ADDENDUM NO. 2

PROJECT TITLE:
REPLACEMENT OF MNRR BRIDGE OVER ATLANTIC STREET - PHASE 1
I-95 NB EXIT 8 RAMP BRIDGE

DRAWING TITLE: **RETAINING WALL 107 WALL DETAILS - 1**

DRAWING TITLE: RETAINING WALL 107 WALL DETAILS - 3

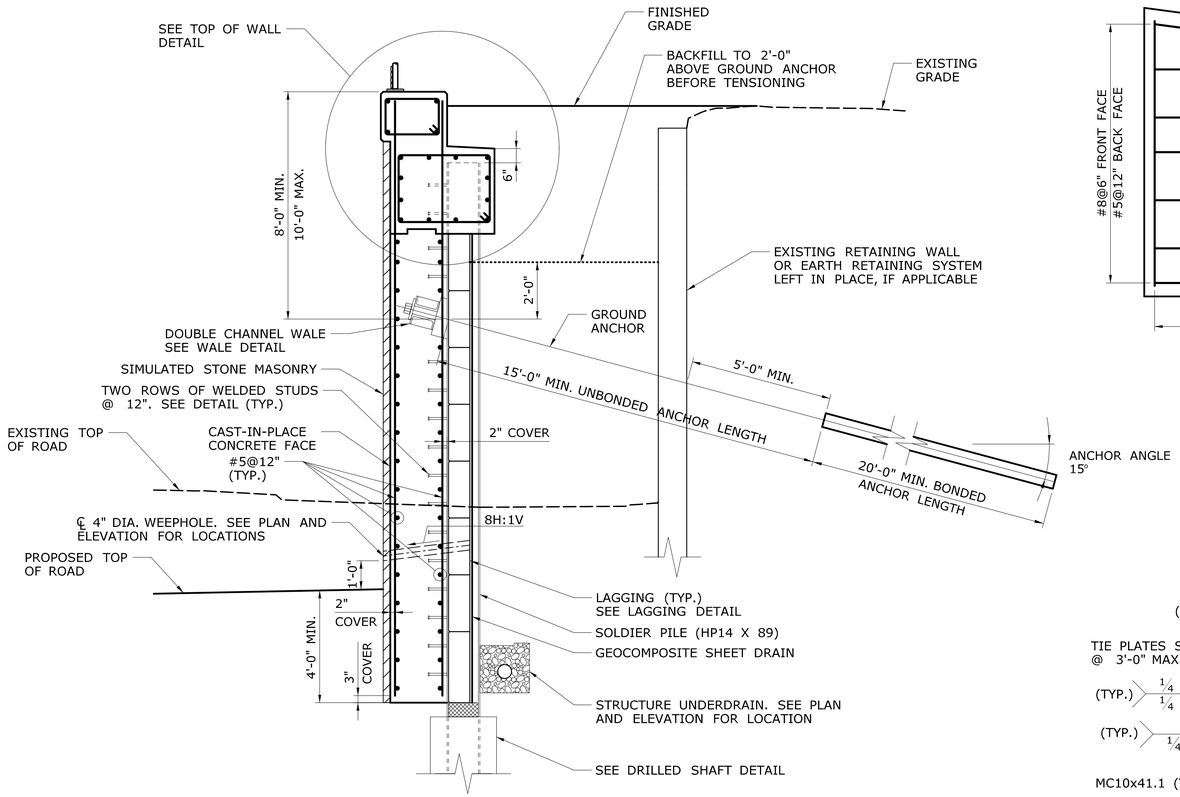
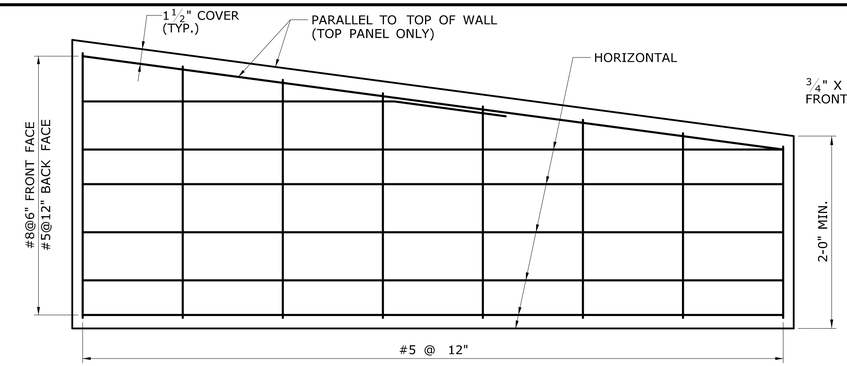
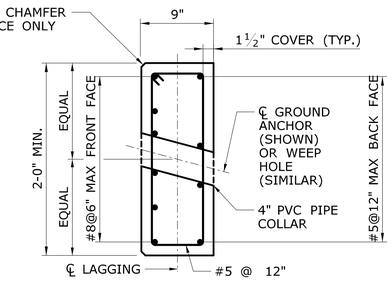
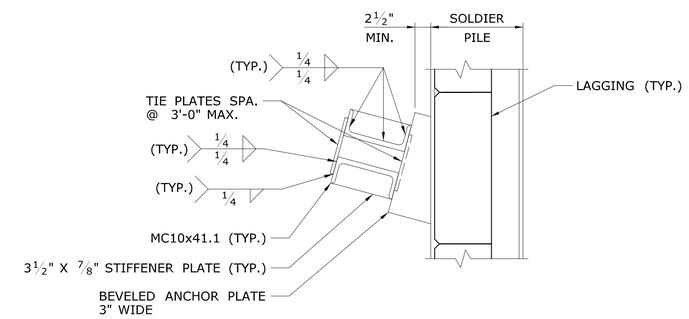
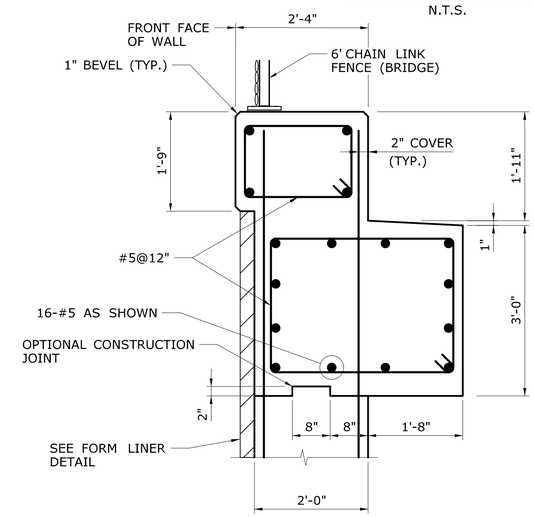
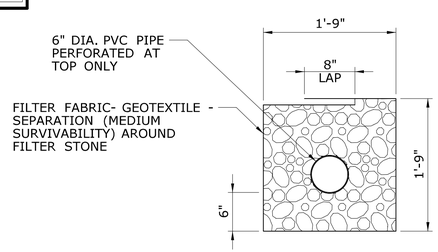
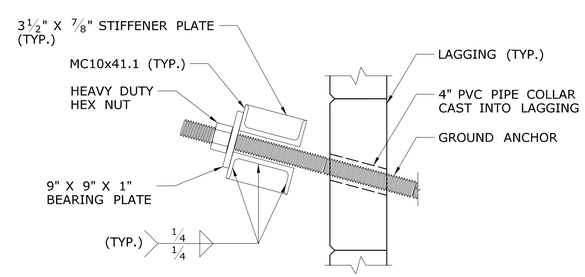
REV.	DATE	REVISION DESCRIPTION	SHEET NO.
1	9/11/15	ADDENDUM NO. 2 - REVISED NOTES

1. CLASS I CORROSION PROTECTION SHALL BE PROVIDED FOR ALL GROUND ANCHORS. WORKING DRAWINGS OF THE FINAL DETAILS OF THE CLASS I CORROSION PROTECTION SHALL BE SUBMITTED TO THE ENGINEER FOR APPROVAL. SEE "RETAINING WALL 107 / WALL DETAILS - 4" FOR SUGGESTED DETAILS.

2. ANCHOR DETAILS (I.E. BAR DIAMETER, STRESSING LENGTH, BOND LENGTH, HOLE DIAMETER, ETC.) SHALL BE DESIGNED BY THE CONTRACTOR AND SUBMITTED TO THE ENGINEER FOR APPROVAL. THE MINIMUM BOND LENGTH SHALL BE 20 FEET. ALL COSTS SHALL BE INCLUDED IN THE ITEM "GROUND ANCHOR". SEE SPECIAL PROVISION.

3. GROUND ANCHORS SHALL BE DESIGNED FOR A SERVICE LOAD OF 145 KIPS PER ANCHOR.
4. A "PERFORMANCE TEST FOR GROUND ANCHOR" SHALL BE PERFORMED ON THE FIRST THREE PRODUCTION ANCHORS AND ON A MINIMUM OF TEN PERCENT OF THE REMAINING PRODUCTION ANCHORS THEREAFTER, AS DIRECTED BY THE ENGINEER. A "PROOF TEST FOR GROUND ANCHOR" SHALL BE PERFORMED ON ALL ANHCORS THAT ARE NOT PERFORMANCE TESTED.

BACKFILL CLOSURE DETAIL
SCALE: 1 1/2" = 1'-0"

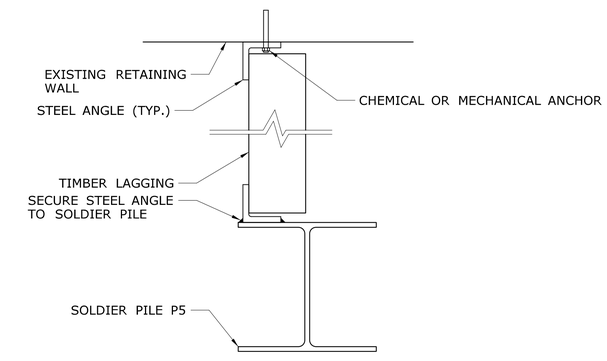
REV.	DATE	REVISION DESCRIPTION	SHEET NO.
1	9/11/15	ADDENDUM NO. 2 - ADDED NOTE

NOTE: CONTRACTOR TO DESIGN CLOSURE BETWEEN EXISTING RETAINING WALL AND PROPOSED RETAINING WALL.
